# 265 CENTRUM

CITY COMMENTS RESPONSE

January 12, 2024

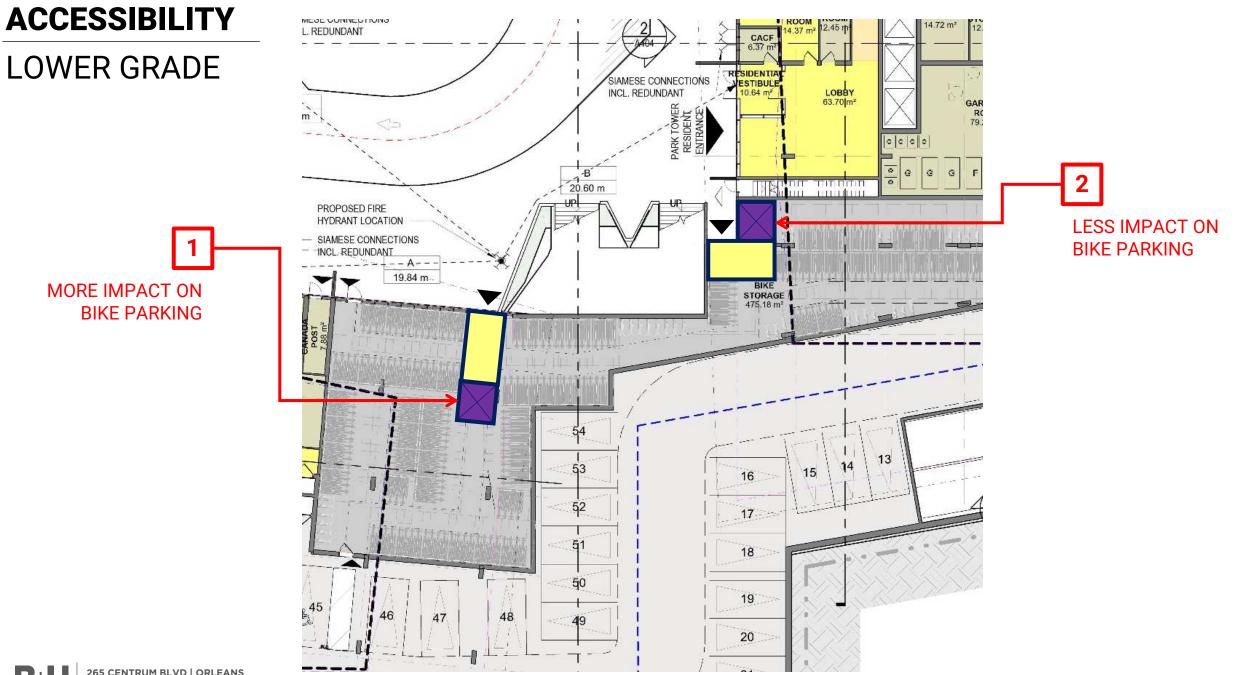
4.8. The pre-consultation comments noted the need for an AODA compliant pedestrian connection from Centrum to the entries of Towers B and C. Neither the pre-consult concept, nor the concept of September 2022 suggested that this would not be possible (both images below).

The current submission shows a significant staircase, which is in no way accessible. People living in Tower C, who may use wheelchairs, canes, walkers, strollers etc. will be required to go all the way around Brisebois to get to any uses on Centrum, including bus service.

The plan needs to be reworked to include an AODA compliant connection, as clearly noted in the original pre-consult comments provided in Spring 2022.
